TO: CITY OF NOVI PLANNING COMMISSION
FROM: SRI RAVALI KOMARAGIRI, PLANNER
THROUGH: BARBARA MCBETH, AICP, CITY PLANNER
SUBJECT: JSP 15-40 NOVI PLAZA FACADE SITE PLAN EXTENSION
DATE: FEBRUARY 07, 2019

PLAN REVIEW CENTER REPORT
January 09, 2017
Planning Review: Preliminary Site Plan
Novi Plaza Facade
JSP 15-40

Novi Plaza Façade
JSP15-0040

Re: FACADE ORDINANCE – Final Site Plan Review
Novi Plaza, PSP16-0192
 Façade Region: 1, Zoning District: B-1

SHEET# SP1.02
DATE: 6 DEC 16
JOB# 13037

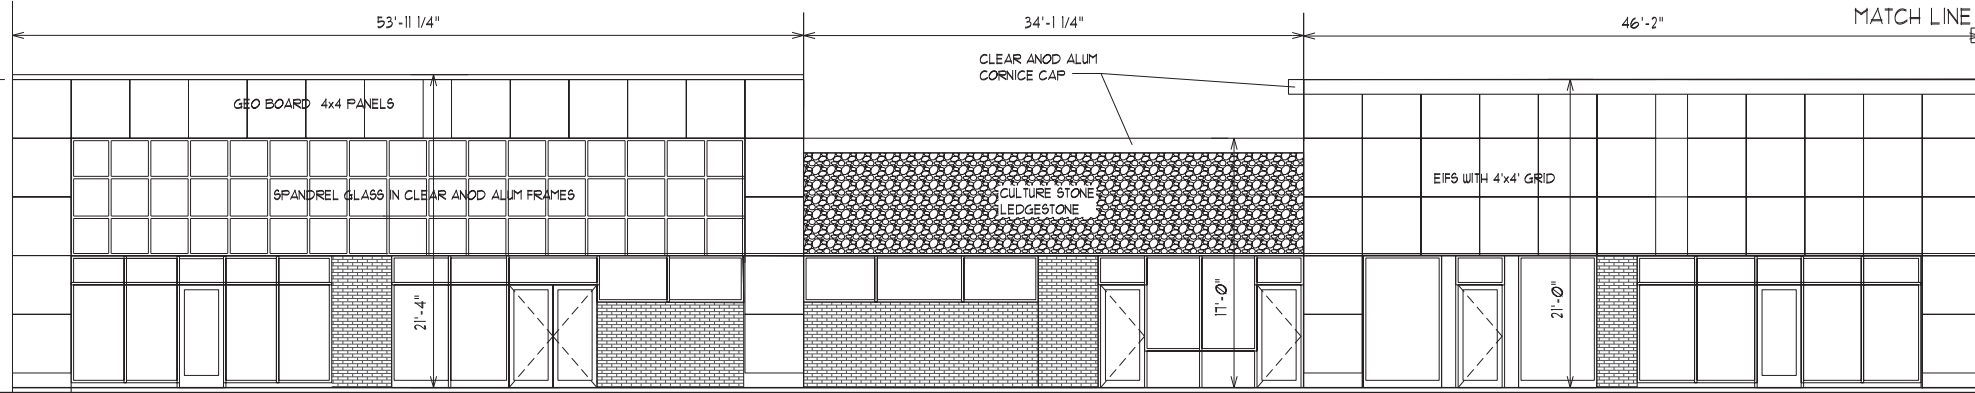
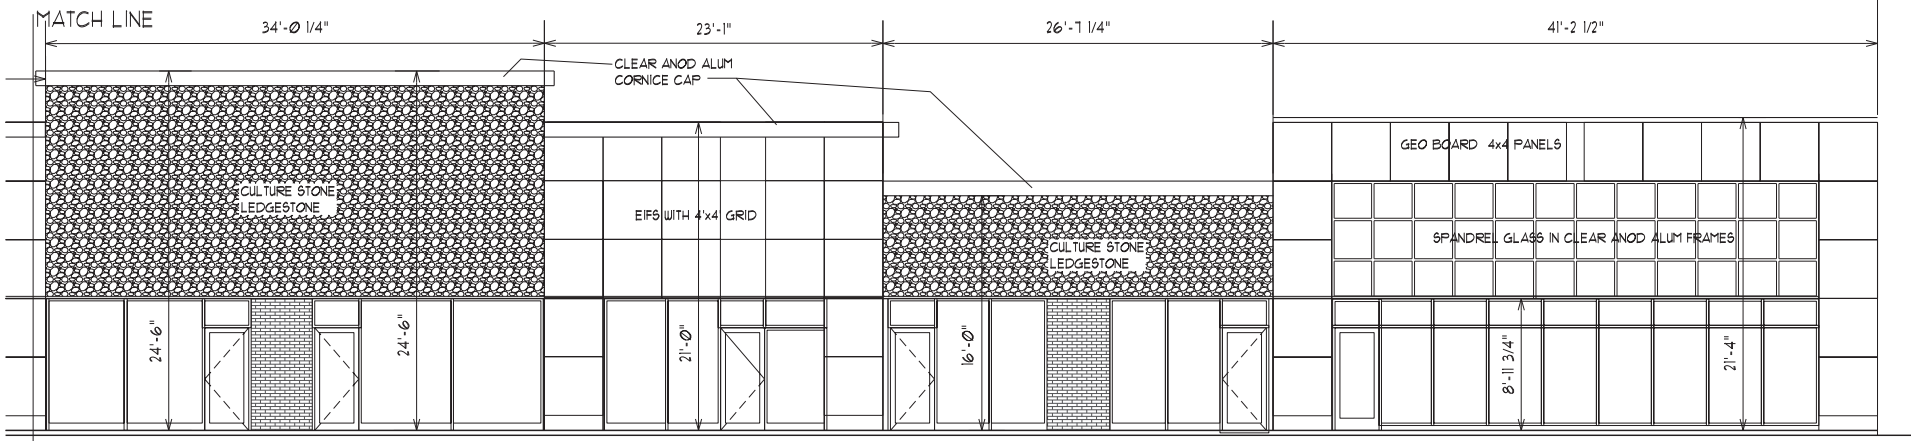
8 MR. ZUCHLEWSKI: I understand,
9 but the drawings and elevations, nothing
10 matches and the site is -- it's deplorable.
11 I think we need to bring this up before we
12 approve it.

The proposed design includes the extension of the buildings parapets from 4' to 12' above the existing roof line on the front (north) façade and 4' above the existing roof line on the east and west facades. This will screen the extensive amount of unsightly roof-top equipment existing on the building and significantly improve the overall appearance of the building as viewed from 10-Mile Road. Drawings of the south elevation were not provided. The lower portion of south façade is substantially screen by an existing decorative fence and evergreen plantings. However, the roof-top equipment is visible on the south façade, albeit to a lesser degree that the other facades. The applicant should therefore consider adding screening of the roof top equipment on the south façade. The areas of CMU on the east and west facades represent existing materials that are incorporated into the overall design in an aesthetic manner.

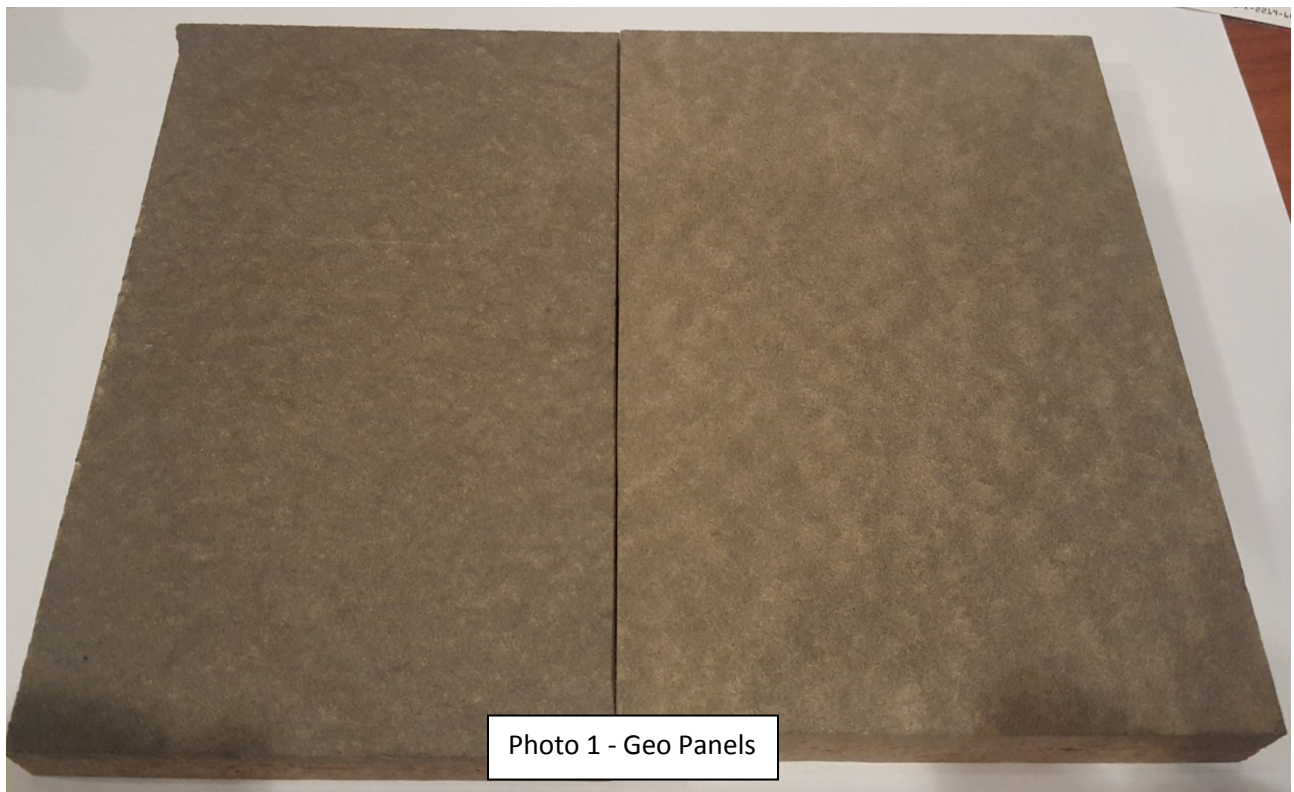
The “Geo Board 4 x 4 Panels” material has been treated as Glass Fiber Reinforced Concrete (GFRC) for this review as this material has similar visual properties. A photograph of this material was provided by the applicant (Photo 1). The applicant has indicated that the “Cultured Stone” will be as manufactured by Stone Works 43” x 8” x 1 3/4” panels, or equal (Photo 2).
